VILLAGE BOARD AGENDA

To: Village of Mount Horeb Plan Commission
From: Village Planner Ben Rohr, AICP
Date: September 25, 2024
Re: Proposed Zoning Map Amendment from Planned Development with underlying Elderly Housing Residential (R-4) zoning to a modified Planned Development - General Development Plan (GDP) for a 1-Story Multi-Family Building at 325 N. 8th Street for Gates Village, LLC.

To: Village of Mount Horeb Plan Commission
From: Village Planner: Ben Rohr, AICP
Date: September 25, 2024
Re: Specific Implementation Plan (SIP) and Design Review for a Proposed 1-Story Multi-Family Building at 325 N. 8th Street for Gates Village, LLC.

SITE PLAN

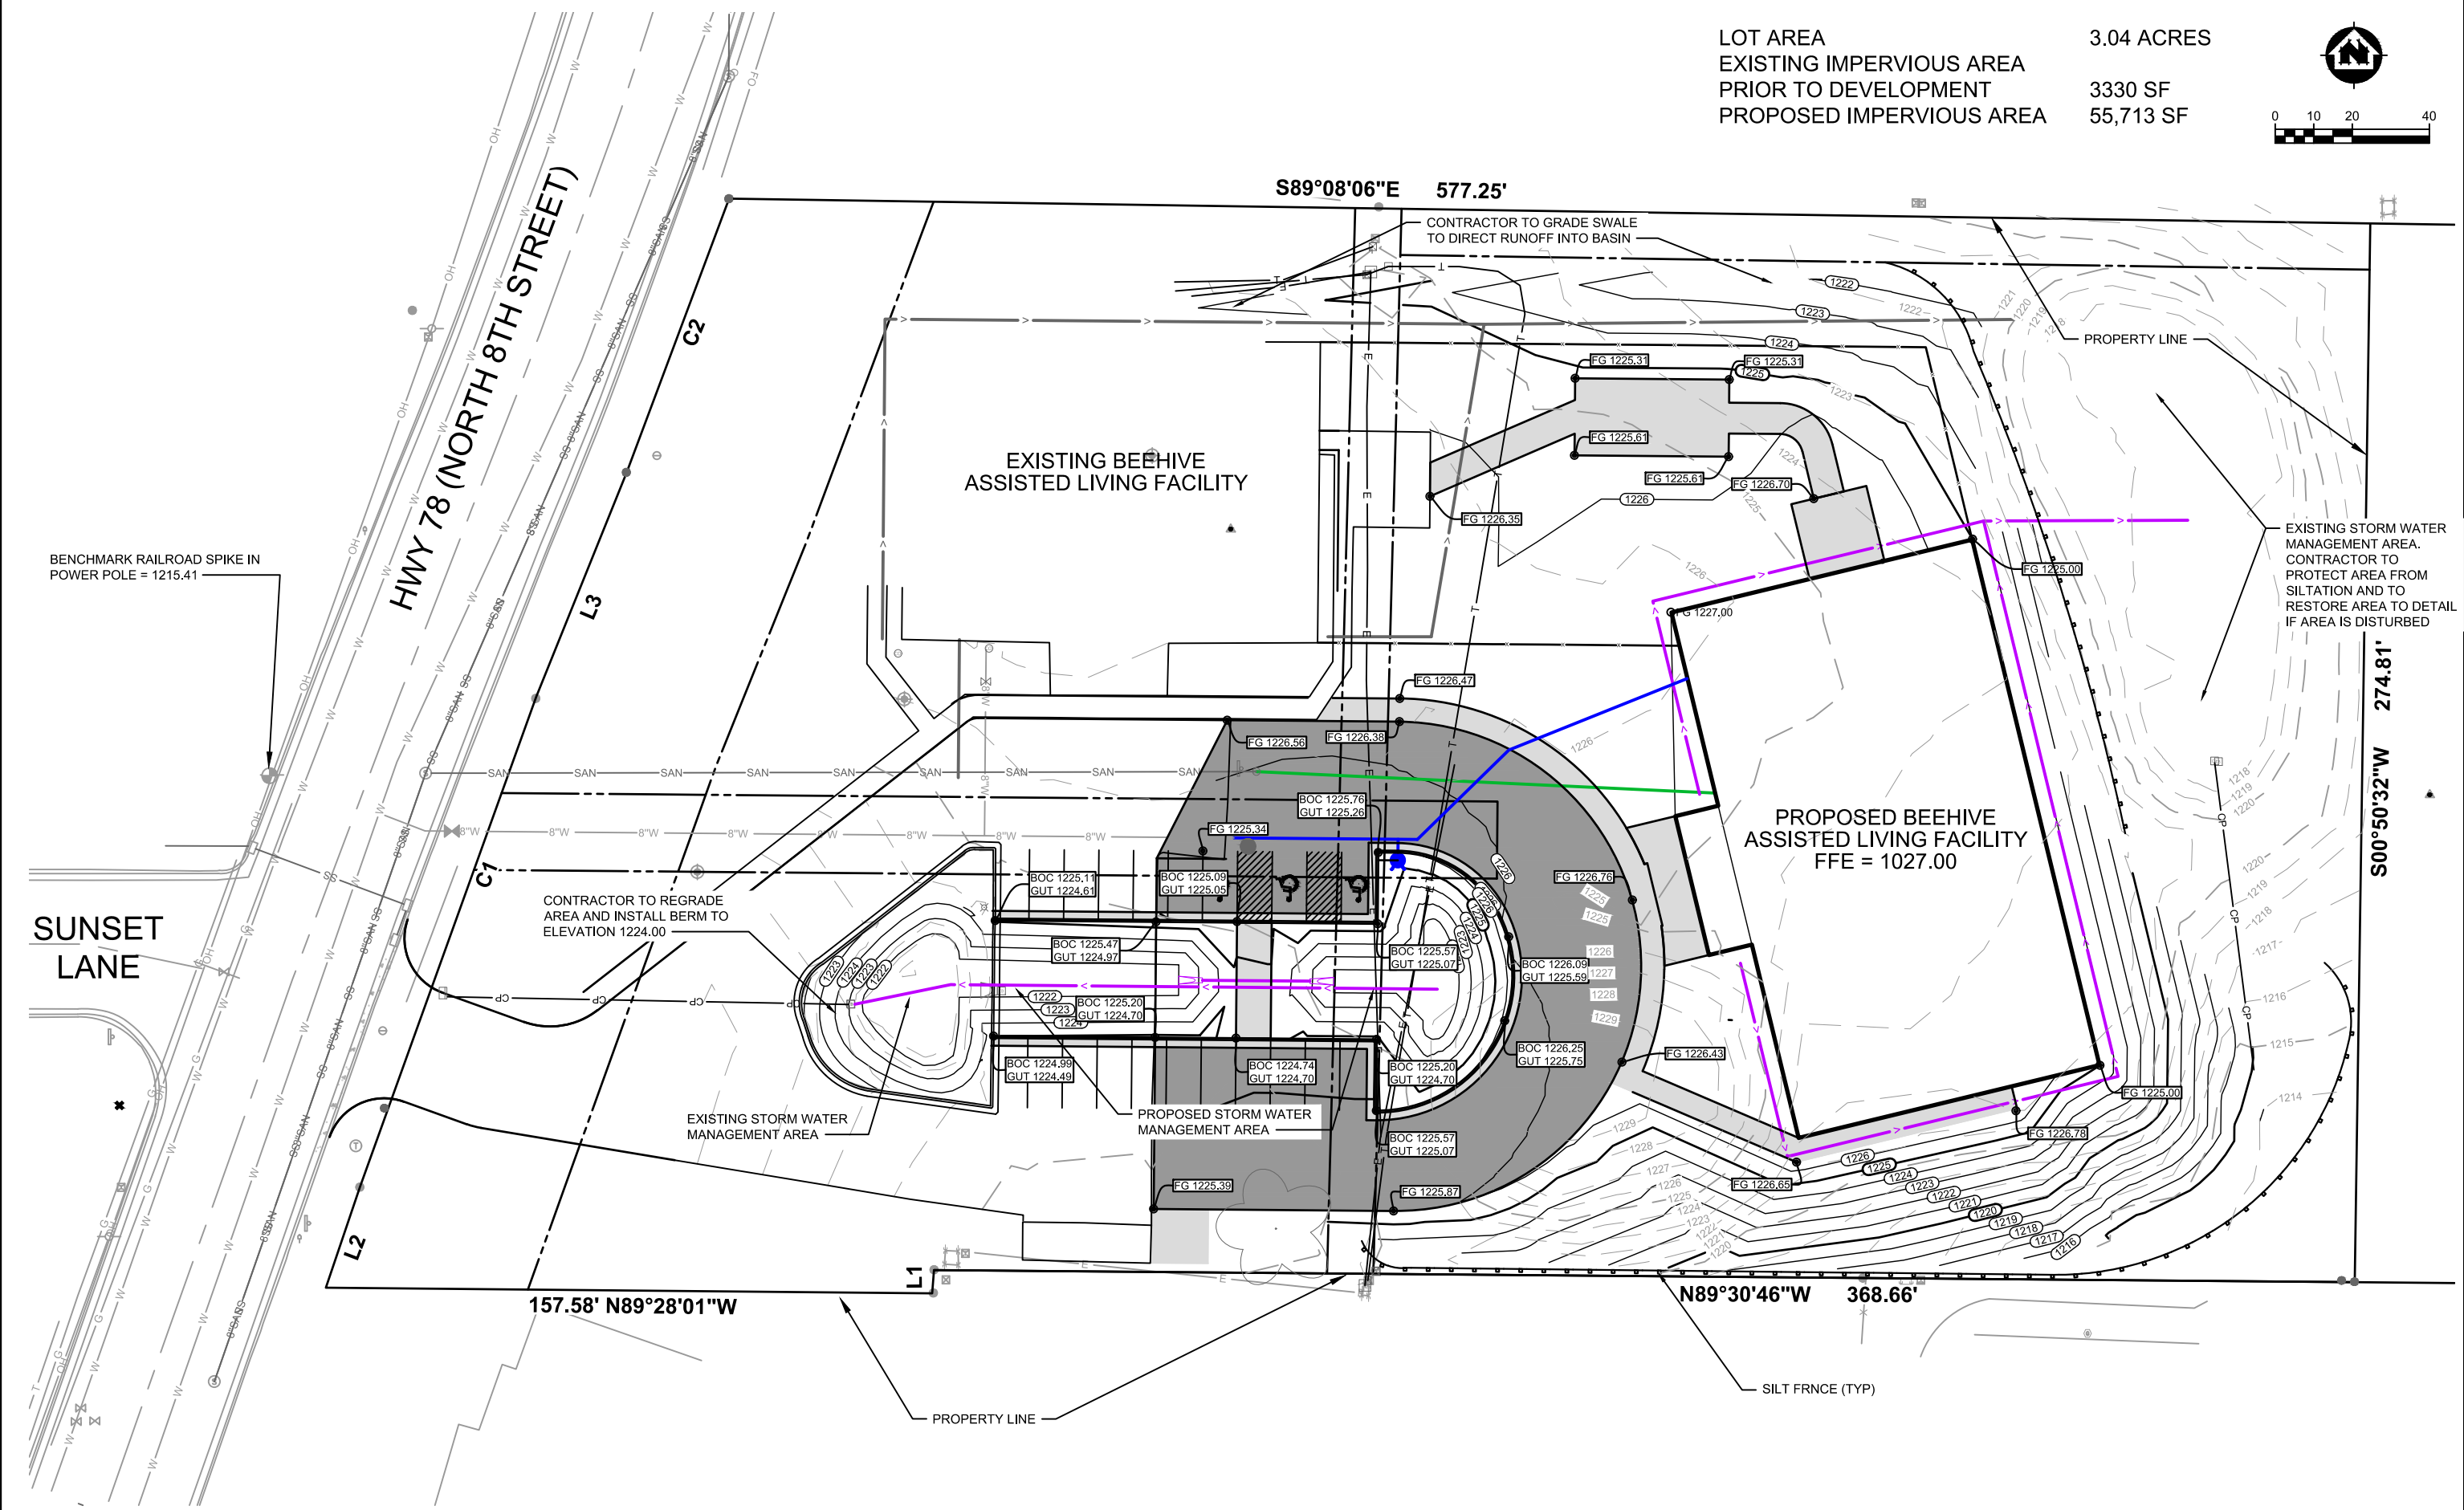
- a. Trash containment structures shall be designed to fully conceal trash storage.
 - It is unknown if this requirement is met. No dumpster plans have been provided, but a concrete dumpster pad is shown on the plans that must meet minimum accessory structure setbacks.

- b. Trash containment structures shall be constructed in the same materials and colors as the ground floor of the principal building.
 - It is unknown if this requirement is met. No dumpster plans have been provided, but a concrete dumpster pad is shown on the plans that must meet minimum accessory structure setbacks.

- It is unknown if this requirement is met. No dumpster plans have been provided, but a concrete dumpster pad is shown on the plans that must meet minimum accessory structure setbacks.

- a. 15.a-c. dumpster plans that include elevations, materials, height, configuration, and meets the minimum 5' accessory structure setback.
 - b. 17.b. fencing plans that include heights, materials, elevations, and designs.

LANDSCAPE PLAN

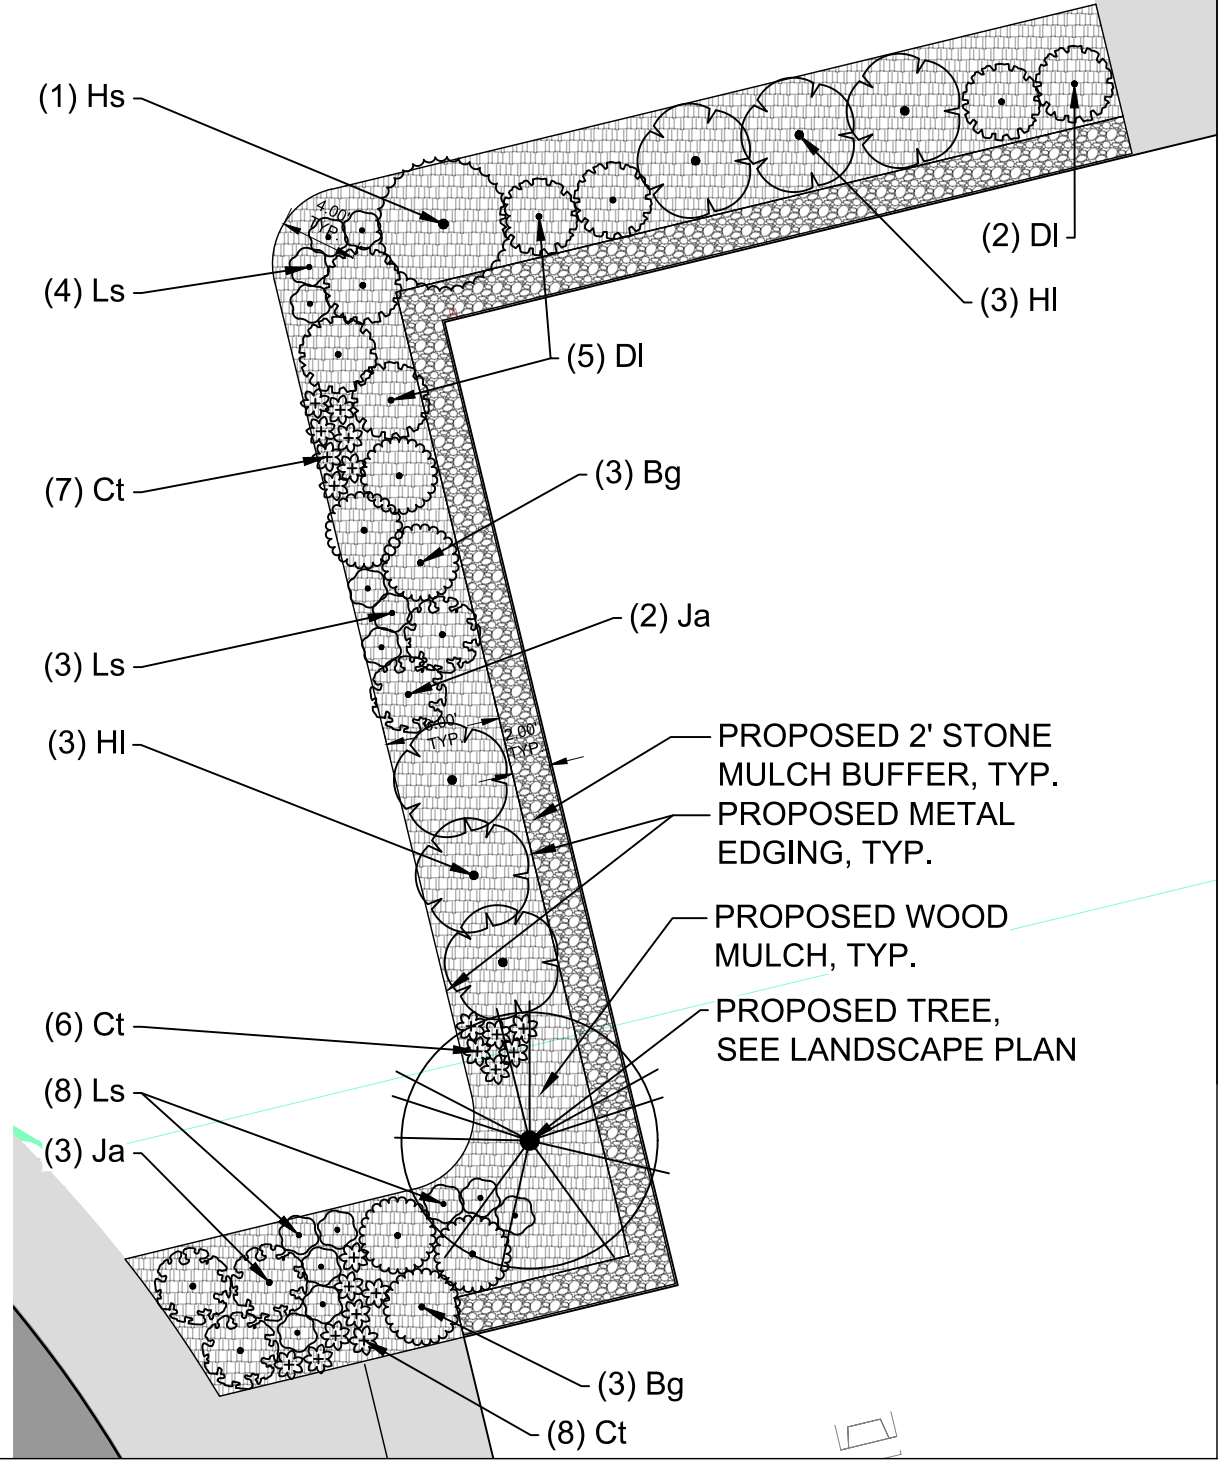
- a. A minimum 10-foot wide landscaping bed or planter shall be provided along at least 50% of each wall facing a street, drive or parking area, except within the downtown area.
 - This requirement is met. Building foundation plantings are provided.
- b. This bed or planter shall be located adjacent to or within 10 feet of the building foundation.
 - This requirement is met. Building foundation plantings are adjacent to the structure.
- c. This bed or planter shall be landscaped appropriately as determined by the Plan Commission.
 - This requirement is met.

- c. 18.e. freestanding light pole heights that meet the maximum 20' requirement.
 - d. 27.a. additional landscaping is provided on the north and/or south property lines to provide additional screening and to meet the parking lot landscaping requirements.

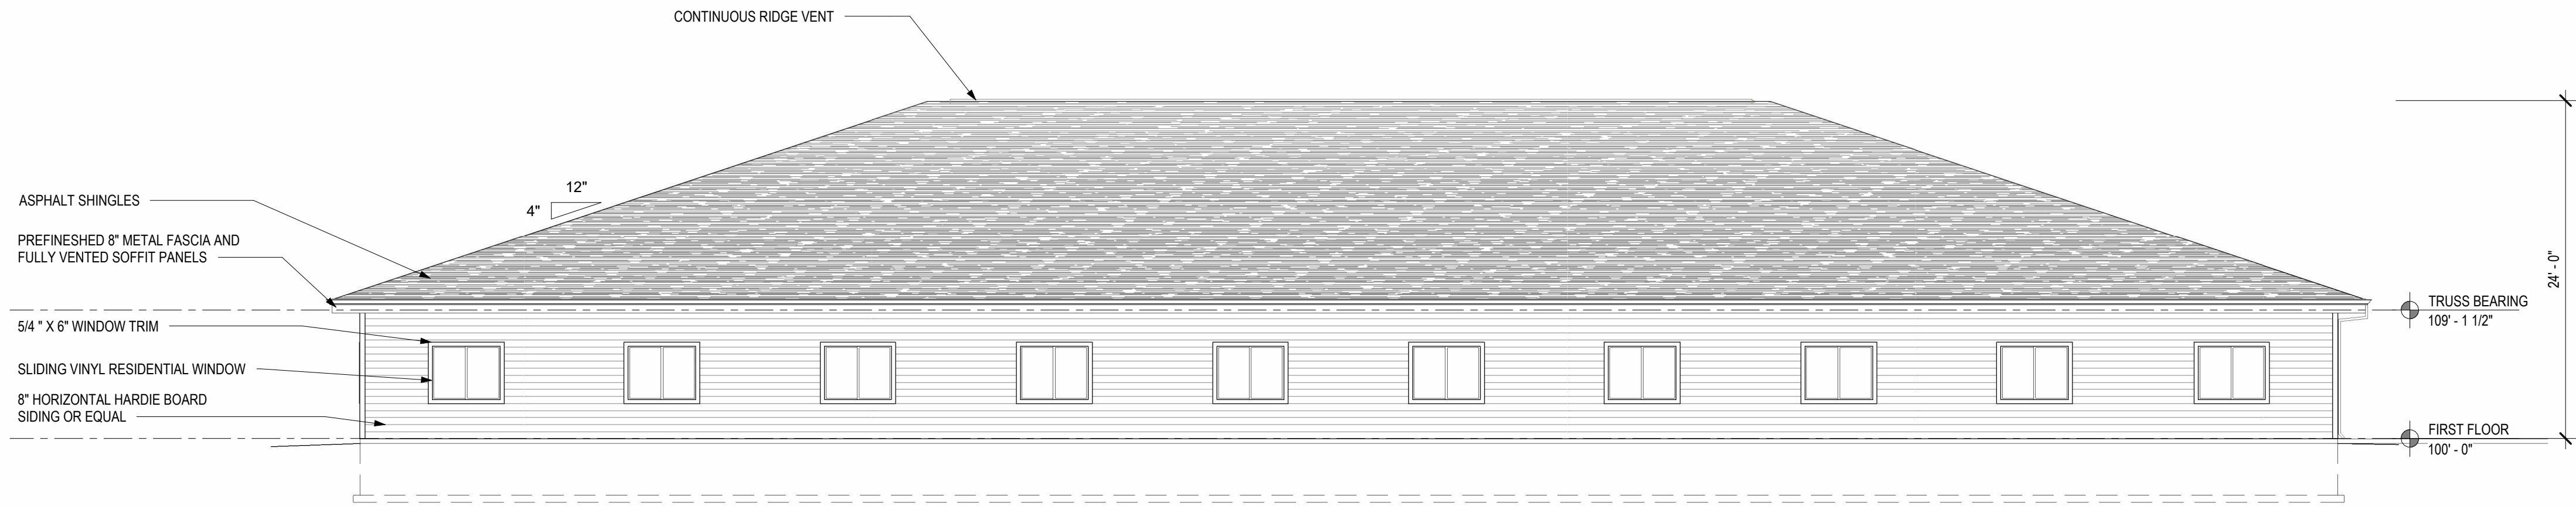
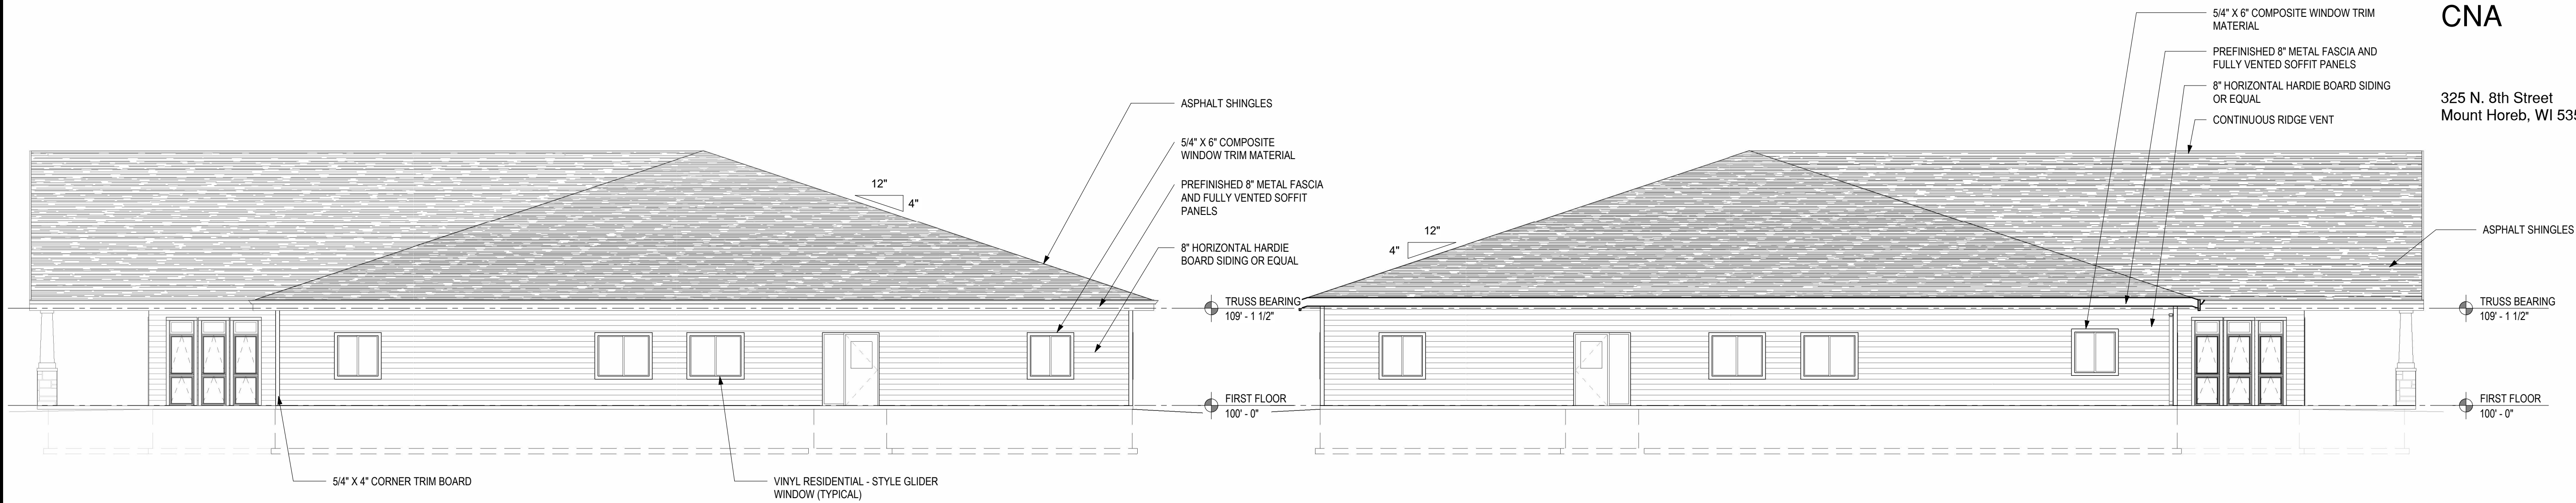
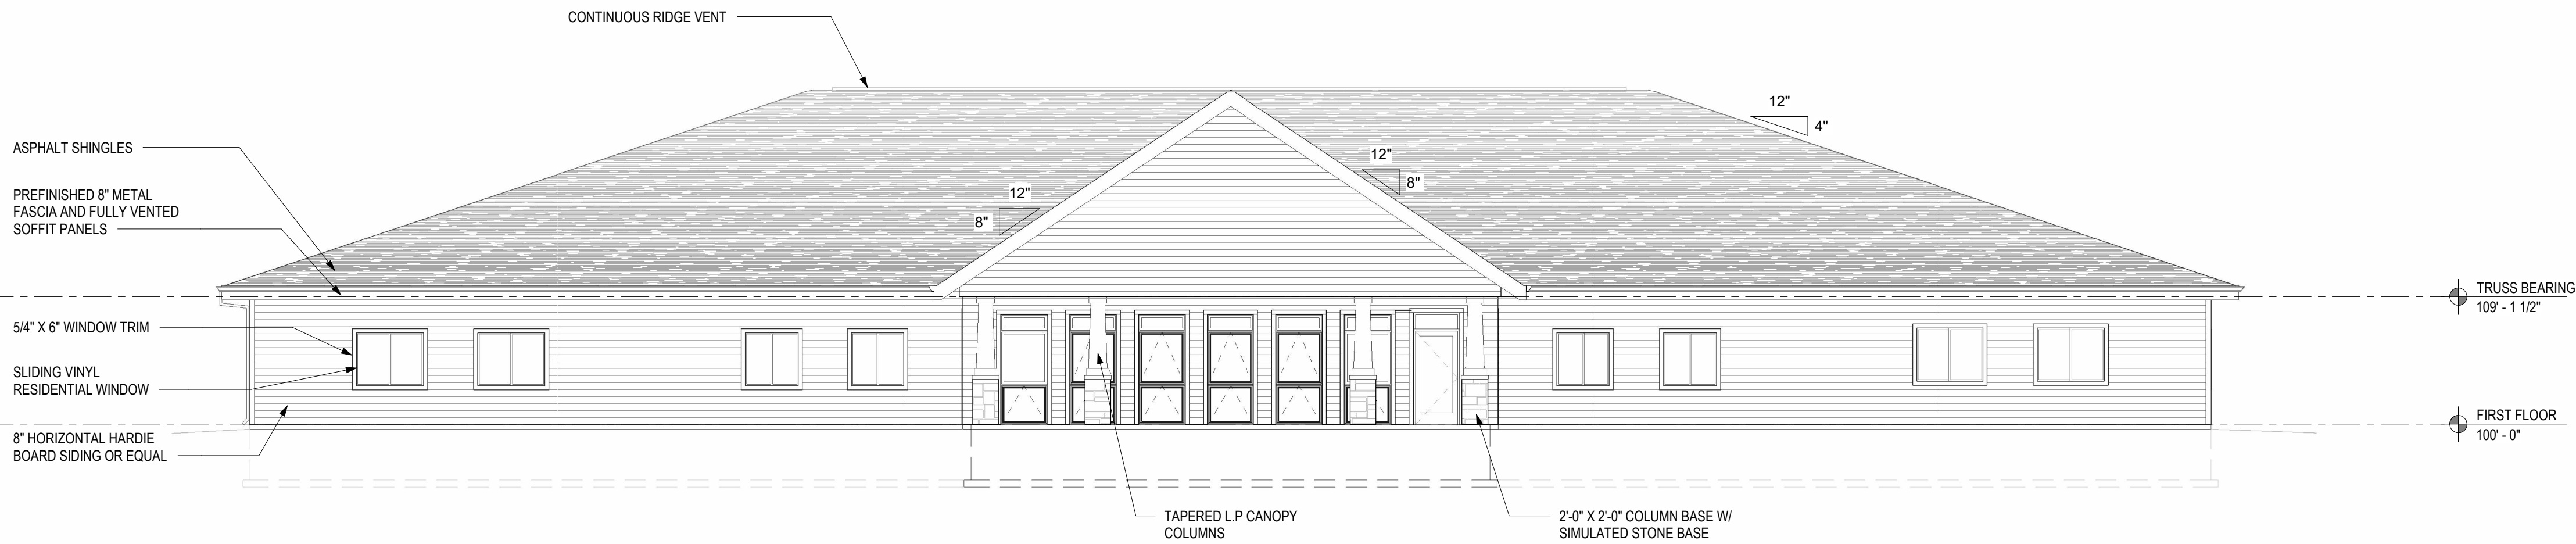
- a. Long building facades shall be visually broken up and variegated with staggers and offsets as determined appropriate by the Plan Commission.
 - This requirement is not met. The building provides very little articulation along each facade. However, the proposed building style is consistent with the existing structure on site and the neighboring residential properties. I recommend that this standard be waived.
- b. All building facades facing streets, drives or parking areas shall provide regularly spaced openings for windows and doors, and regularly spaced decorative elements such as piers and

- This requirement is met. Doors, windows, and canopy-supporting pillars are provided along the western façade.
- c. All building facades facing streets, drives or parking areas shall provide a pattern of upper story openings that is compatible with the pattern established by the ground floor, as determined by the Plan Commission.

- a. All exterior doors visible from streets, drives or parking areas shall provide decorative design elements.
 - This requirement is met. The front façade of the building (west elevation) includes decorative design elements such as glass and canopy-supporting pillars.
